# METROPOLITAN GOVERNMENT OF NASHVILLE AND DAVIDSON COUNTY

## STAFF RECOMMENDATION 2819 Hillside Drive June 18, 2014

**Application:** New construction-infill  
**District:** Hillsboro-West End Neighborhood Conservation Zoning Overlay  
**Council District:** 18  
**Map and Parcel Number:** 10410022000  
**Applicant:** Franz Baudenbacher  
**Project Lead:** Robin Zeigler, robin.zeigler@nashville.gov

**Description of Project:** The project is for a new two-story home with a detached garage to replace a house that was demolished prior to the establishment of the extension of the overlay.

ROOF PLAN

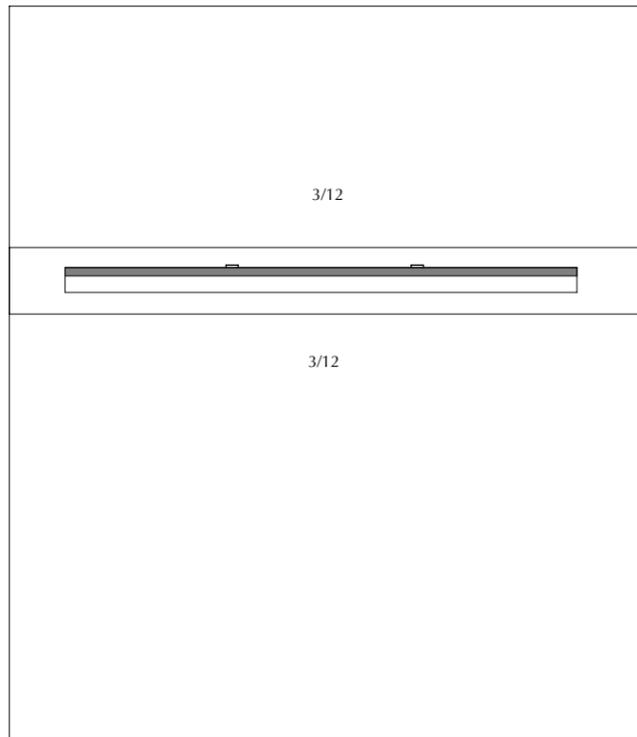
Roof form: The applicant proposes a deconstructed front-gable roof form that is not seen in the overlay. The Commission approved a deconstructed cross-gable form in a different neighborhood, but after construction, decided that it did not meet the design guideline’s requirement that roof forms for new construction be “visually compatible, by not contrasting greatly, with the roof shape, orientation, and pitch of surrounding historic buildings.” The Commission expressed its interest in not approving these forms in the future and typically directs applicants to match an existing form in the district. Prevalent roof forms found in the district include cross gable, side gable, and hipped forms.

Proposed roof form.

Based on the fact that roof forms should be visually compatible with historic roof forms and should not contrast with these forms, staff recommends a side-gable form to meet section II.B.1.e.

ELEVATIONS

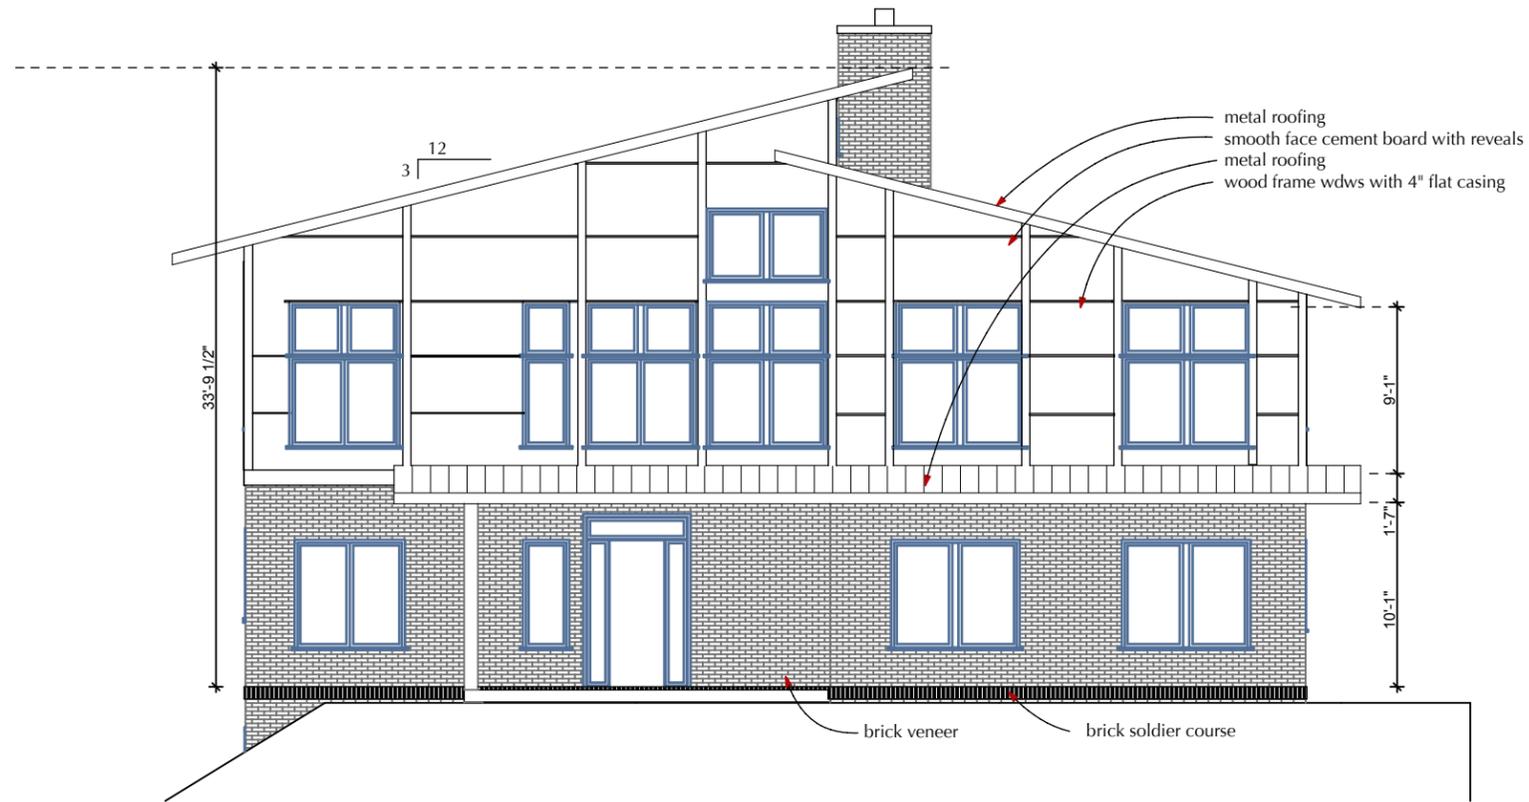
There are only a handful of front-gable homes in the district and all of them are one or one and one-half stories rather than two-stories. Two-story building forms typically have a side-gable roof form, in this portion of the district, and hipped elsewhere in the district.

The guidelines require that roofs have a minimum of a 6/12 pitch, as that as is what is typically seen on historic buildings. However, the two side-gabled two-story forms found in the district have a pitch of approximately 3/12.

Proportion and Rhythm of Openings: There are no expanses of wall that are greater than approximately ten feet (10') without some time of break. The front facades of historic homes typically have windows every eight to ten feet (8'-10'). The majority of windows are appropriate, being twice as tall as they are wide. There are some accent windows that do not meet this proportion; however, this type of mix of window sizes is seen on historic building. The project meets Section II.B.1.g because it maintains the rhythm of openings and window proportions found on the historic buildings.

- Roof form be a side gable, similar to the only other 2-story buildings in the immediate vicinity;
- All double and triple windows have a 4" to 6" mullion between them;
- The porch floor be concrete, wood or a wood composite;
- The foundation brick be a different color than the first-floor brick which should be a historic brick color in order to fully distinguish it as typically foundations are a different material altogether; and
- Staff provide final review of the masonry and windows and doors, trim, screen porch, walkway and driveway materials/design.

SIDE ELEVATIONS

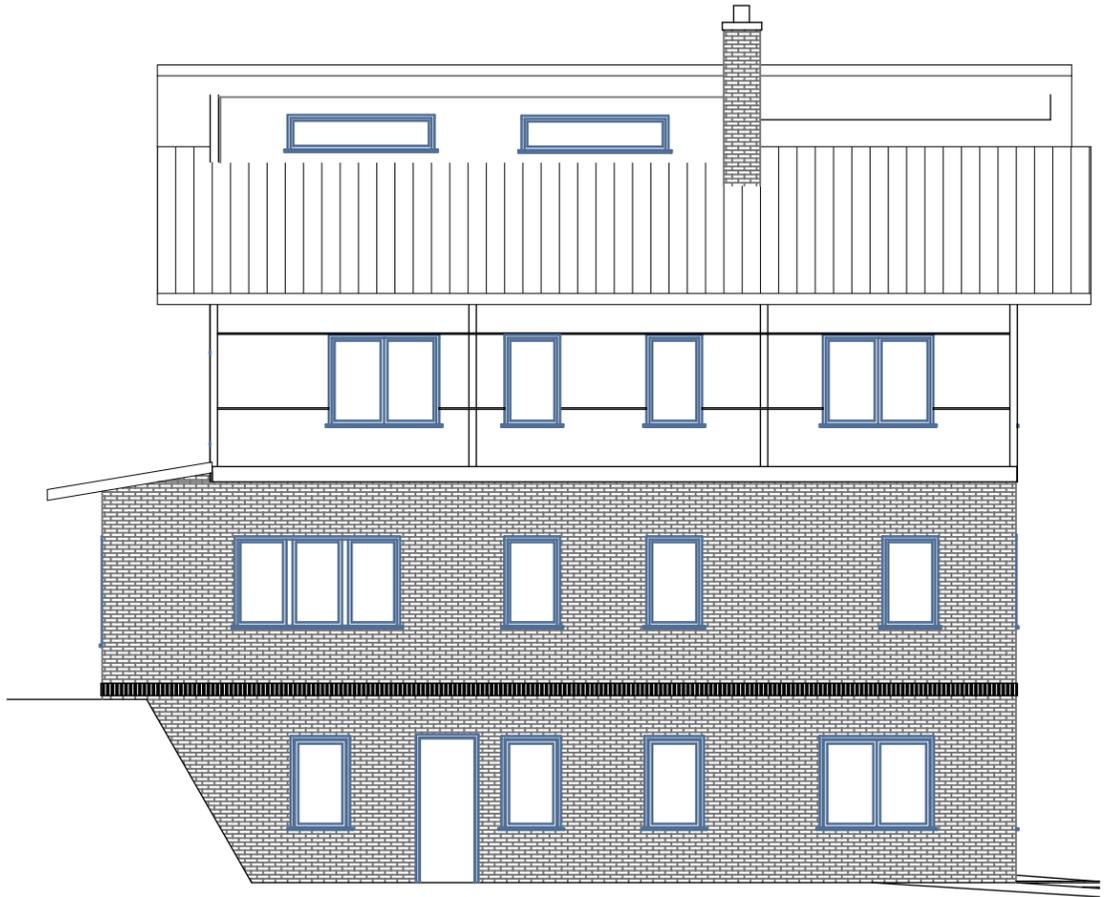
Materials: The cladding is proposed to be brick on the first floor and smooth-faced cement-fiber panels on the second floor with a skirt-board to create a transition between the two materials. The foundation will be brick distinguished with a soldier course. Staff recommends that the brick foundation be a different color than the first floor cladding to further distinguish it as typically foundations were a different material altogether. The roof will be a slate-gray colored standing-seam metal. The casement windows are noted as wood; however, the applicant would like to propose aluminum-clad wood windows. Some windows appear to have an appropriate mullion between and some do not. This is likely simply a condition of the printing but to be safe, staff recommends a condition that all double and triple windows have a 4" to 5" mullion between them and that staff provide final review of all windows and doors. Trim, driveway, rear screened porch and door material/design were not indicated. Staff recommends final review of these materials. The chimney will be brick. The brick front porch post will be wider than typical, as seen from the side, but narrow as seen from the front. Typically, staff recommends that porch posts have a capital and base; however, in this case the post is more of a narrow wall and so the cap and base is not necessary. The floor of the front porch is proposed to be a limestone or sandstone colored tile and the walk-way concrete tile. Historically, porches were concrete or wood; therefore staff recommends one of those two materials for the front porch floor and final review of the walk-way material/design. The rear porch will have steel columns and a horizontal stainless steel cable railing. Staff recommends final approval of the material.
